Process REPORT (hereinafter called the "Report")

ALL INSPECT
All Building & Termite Inspections

Inspection Date: 19/01/2016

Property Address: 875 Sample Drive Sample 4300

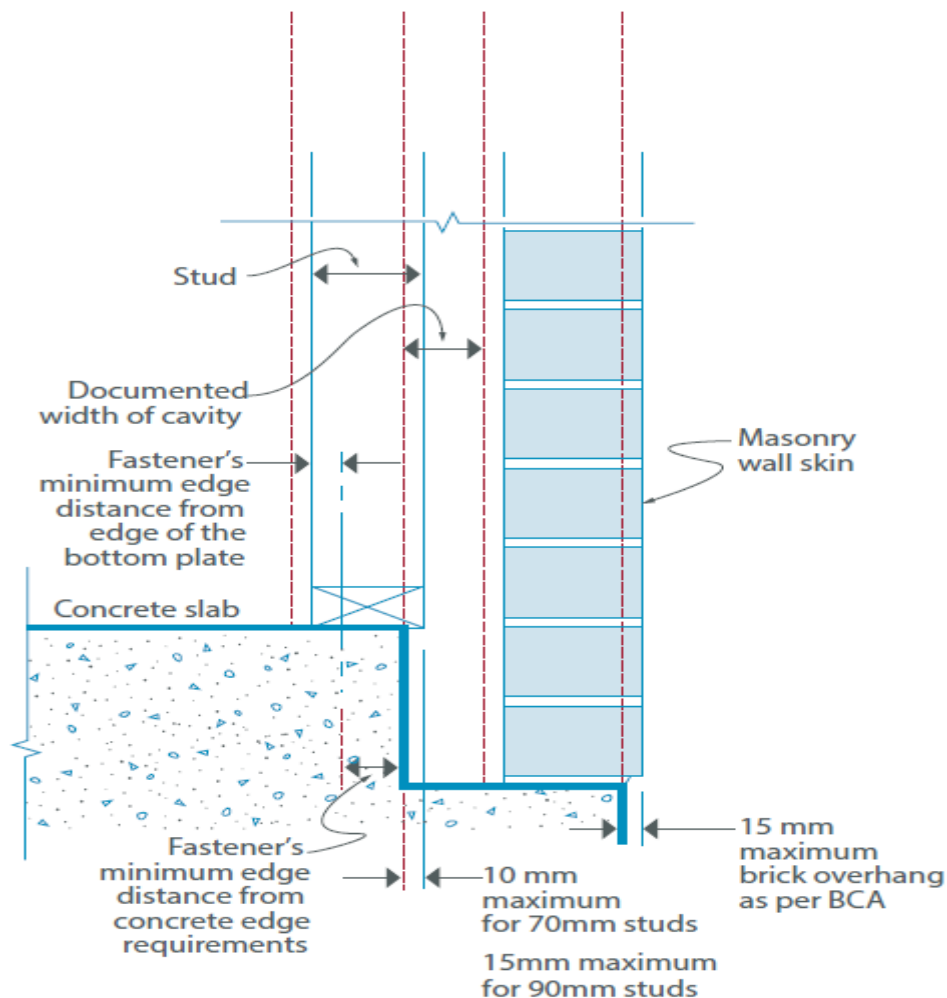
The frame overhang is more than the allowance and needs to be supported in a manner that complies with As 1684.2, clause 6.3.3, and the BCA 15mm for a 90mm frame, and fixings have broken the edges the Standards & Tolerances allowance reference to the 4.11

FIGURE 6.6 NOGGING

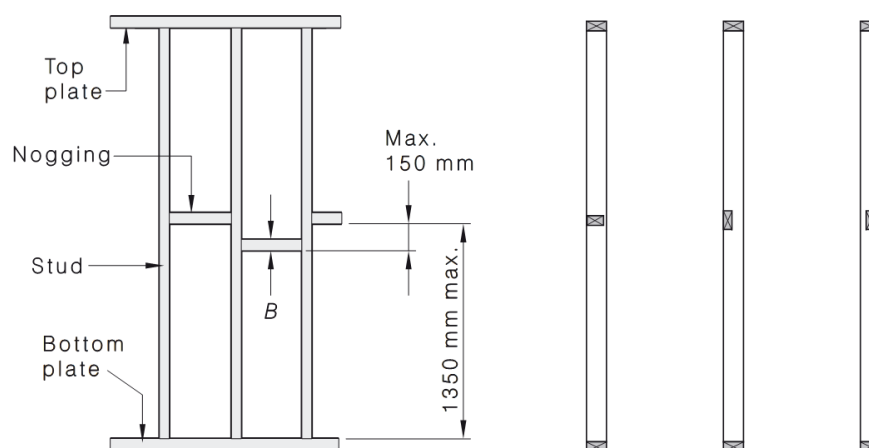
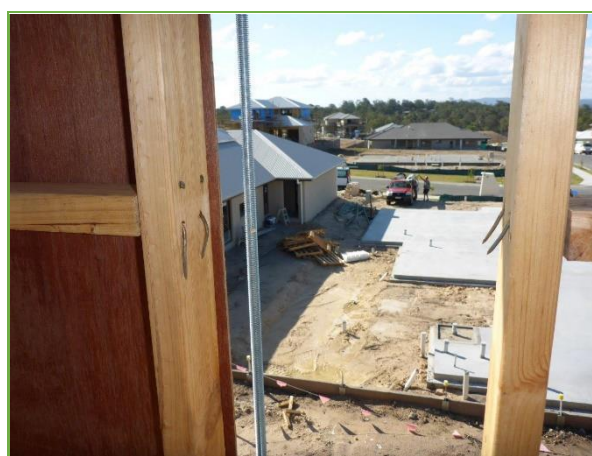
There are several noggings that need to be installed or in parts reinstalled.

I refer the builder to AS 1684.2, clause 6.2.1.5 which calls for all noggings to be installed at no greater than 1350 mm from top or bottom plate and no greater than 1350 centres.

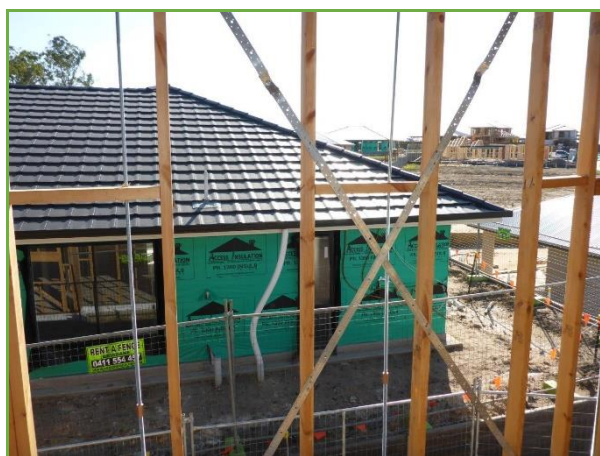
It was noted at the time of inspection that the **Plasmite Termite Blanket** system appears to be incomplete as the barrier in some areas is not under the frame. The tie down rods that have been install to the outside of the frame have push the termite barrier back to the rebait and doesn't comply with AS 3660.1 2000 and the manufacturers instructions and Deemed-to-Satisfy Provisions are an optional means of achieving compliance with the mandatory Performance Requirements. this will need to be reworked and completed before continuing reference for builder.

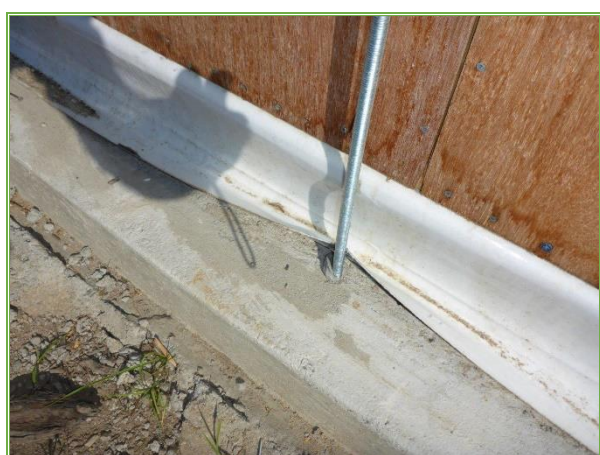
It was noted at the time of inspection that there is holes in the roof sarking, thus allowing the transfer of water moisture to the frame roof void, any moisture running down the Roof will now exit into the void. This will in itself cause additional defects at a later stage. This needs to be complete otherwise considerable rework will have to take place to ensure that the builder comply with requirements of the BCA and Australian standards AS 4200-1994. All holes will need to be patched to comply with Energy efficiency requirements "Pliable Building Membranes and Underlay's" part 2 states: The only tapes that can be used on sisalation are AS 4254 compliant. Please note that any coloured tapes used on the foil side of the sisalation are defective. The tapes used to this side of the sisalation must be designed for installation on a foil surface and hence AS 4254 compliant. Ensuring full coverage of the frame in wall or roof sisalation. Ensuring that penetrations through the sarking by services have been taped to provide a weather tight seal.

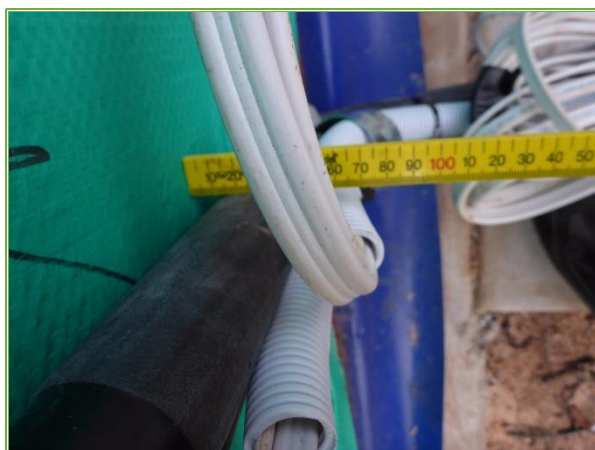
Results: It was noted at the time of inspection that the air condition pipes installed to the cavity area of the dwelling will breach the minimums set down in the bricking Standard.

As such I refer the plumber and the builder to part 9.2. This part clearly states that a cavity must be a minimum of 25mm. Given that the plumbing pipes in the wall are 40mm to 60mm the builder would need a 70 mm+- cavity to make this work.

I noted from the installed slab that the builder's intentions are to install the cavity at about 25 to 35 mm.

Given this configuration, the installation of A/C pipes on site will bridge the cavity.

The plumber will need to return to site and rework all of the external installation prior to brick installation.

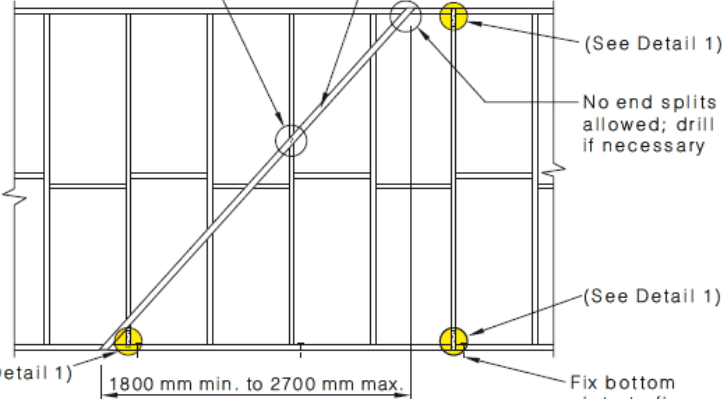
Results: The steel bracing to the dwelling have not been installed with a minimum of two nails to each stud to the marked up areas only. Most areas are compliant.

I refer the builder to AS 1684.2, page 143, table 8.18 that clearly mandates the requirement of a minimum of two nails to each connection.

The additional nailing is required to ensure compliance.

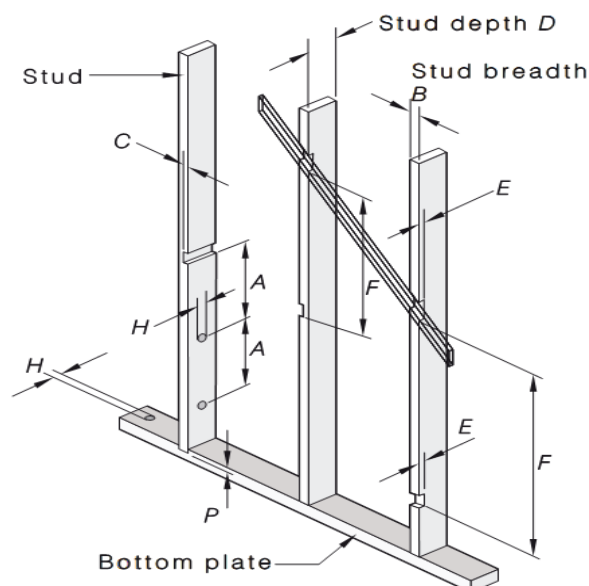
Results: AS 1684.2, AS 3500.1 and AS 3500.4, notching into a stud must be restricted to 20 mm. See Table 6.1, section (e) below. Some of the plumbing water outlets has been installed via notching the studs depth by 30 mm or greater. This needs to be rectified by installing a supporting timber to the stud where the notch has taken place. I refer the builder to the inserted below.
